37/3-95 C 7417 Baltimore Avenue
Takoma Park Historic District

7417 Baltimore Ave
Takoma Park

We, the residents of Cleveland and nearby Baltimore Avenues wish to respond to the application for revision of the approved plans for 7417 Baltimore Avenue, Takoma Park (HPC Case 37/3-95C REVISION)

12/20/96 REAR FACADE - PROPOSED
NOT TO SCALE

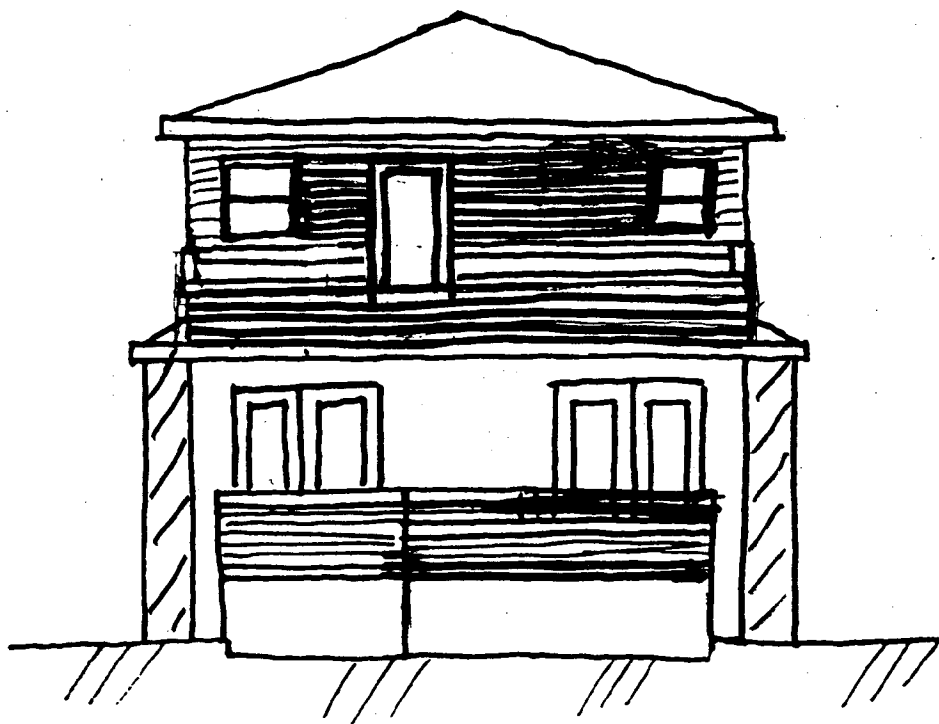
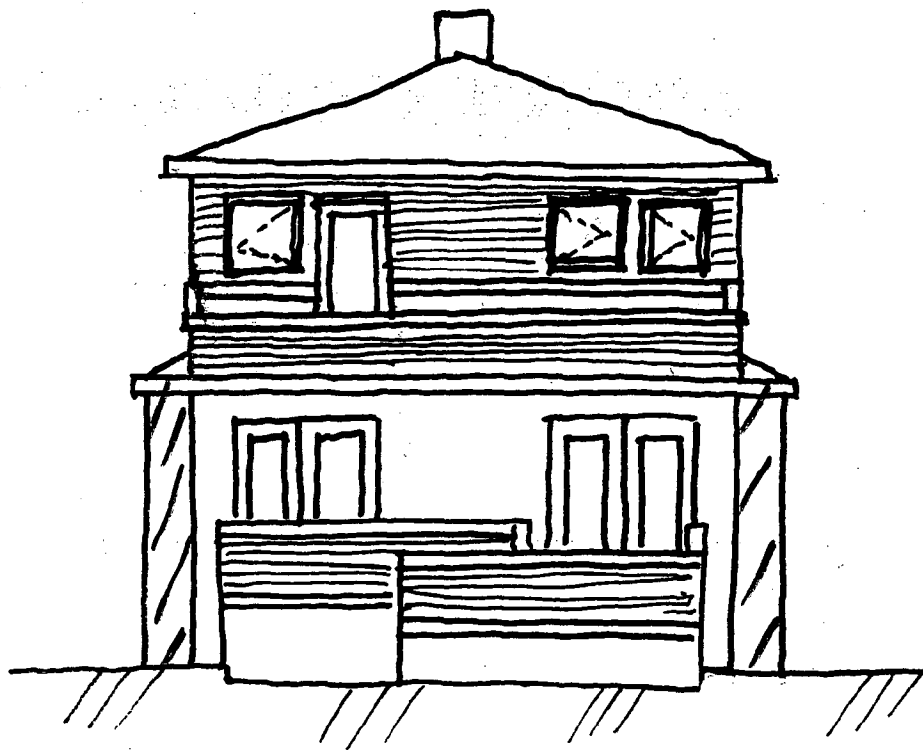
Staff would not support the modification of the door and window placement for the second story rear (east) facade. The proposal calls for elimination of a pair of windows to the right and a paired door and window to the left, and the installation of an off-center door and a window on each side. (The original proposal was for three windows on the left, but was modified to access the balcony.) This design revision would not be in keeping with the Prairie style of the rest of the addition and the original resource. Although it is on the rear, it must be remembered the rear of the house is clearly visible from Cleveland Avenue and its design is of importance. The use of two pairs on the outer corners clearly denotes the Prairie interest in lightening the corners and in eliminating the box.

With regard to the decks approved for the rear addition, staff is strongly of the opinion that the two-level deck should be retained for the first floor in order to maintain the Prairie-like mixture of horizontal planes. Staff, therefore, opposes the proposal of a one-level first floor deck. As the deck is extremely close to the street, staff feels that the quality of its design should be held to the same standard as would a modification on the front of a historic resource.

Change the second story windows from casement to double hung (2'x3') as are used in the rest of the house already. also delete 1 window on the inner right side and move the door more to center on the left side.

- Deny change to double-hung from casement windows on 2nd story, all facades.
- Deny chimney deletion.
- Deny window deletions on west (front) facade and 2nd story of east facade.
- Deny door change on 2nd story of east (rear) facade.
- Deny use of 24" x 36" window pair on 1st floor of north facade.
- Deny first floor deck modification.

12/20/96 SIDE FACADE (FACING NEIGHBOR) - PROPOSED
NOT TO SCALE

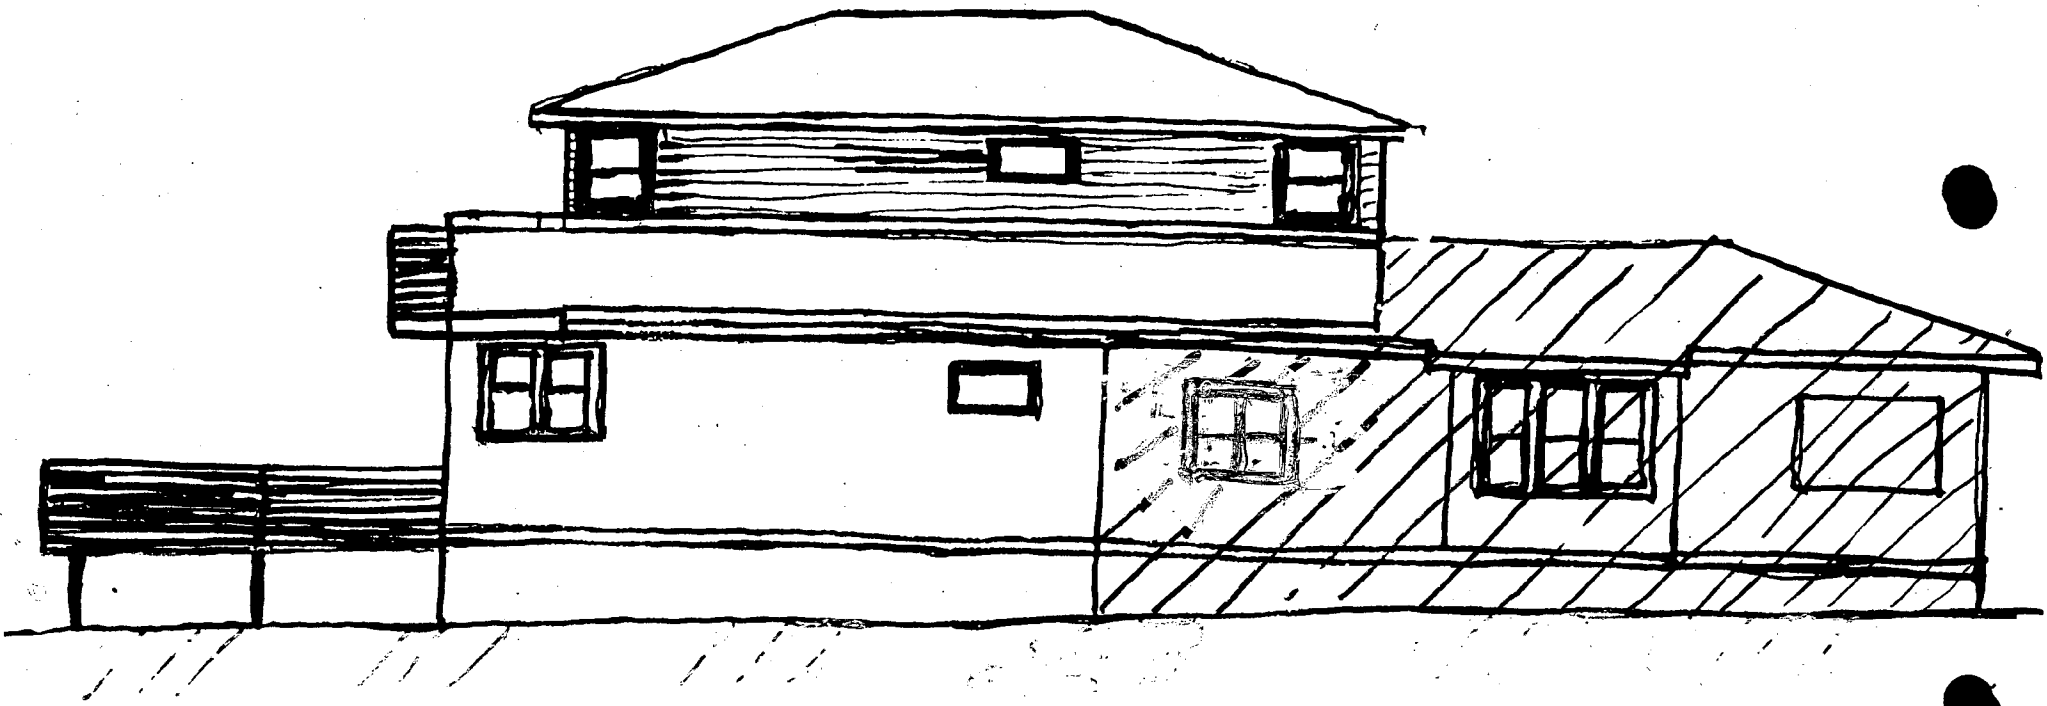
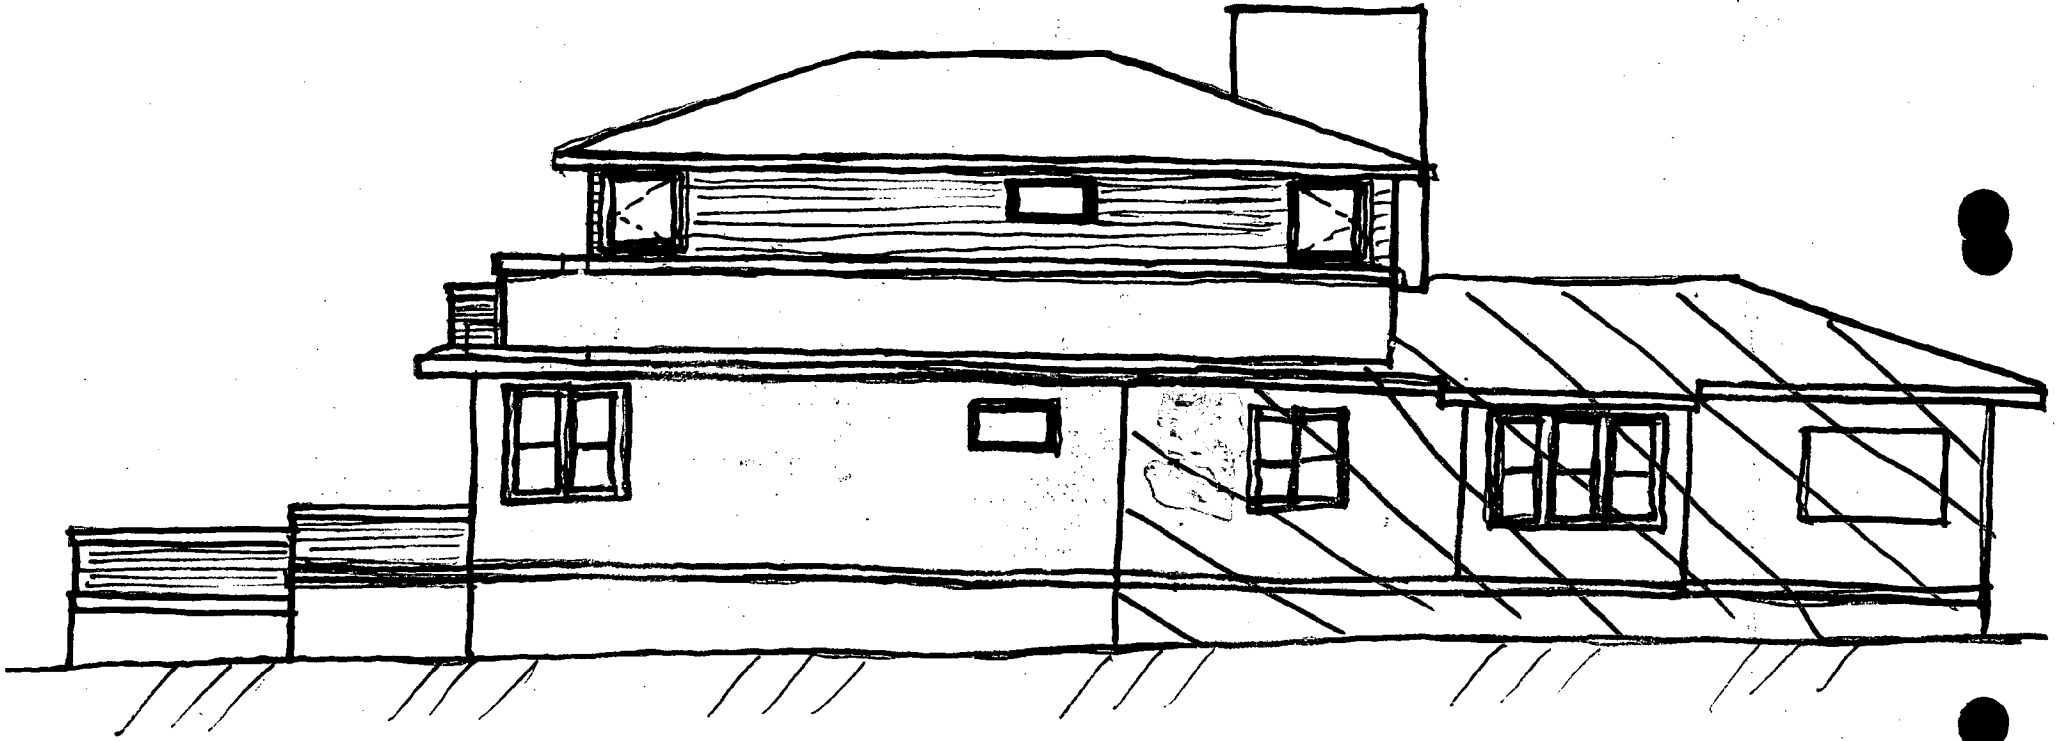
Finally, staff would not support the use of a smaller pair of windows on the north facade. The use of two full-sized windows, 28" x 60", would allow more light into the house on a side where a fence and plantings block light. The larger size would, in staff's opinion, better balance the long blank space between the small window under the eaves and the end window. Although it would require a custom window, it is the only place in the new addition where a full sized window of the same dimension as is used in the original part of the historic resource is planned, and it is the location for which the larger size is most clearly needed.

④ North Facade (Facing the next door Neighbors house)
change the two windows on left side of first floor from two 2'x4' double-hung, to two 2'x3' double-hung in same location.

On the second story, change the two corner windows (2'x3') from casement to double-hung as are used in the entire house already (old & New)
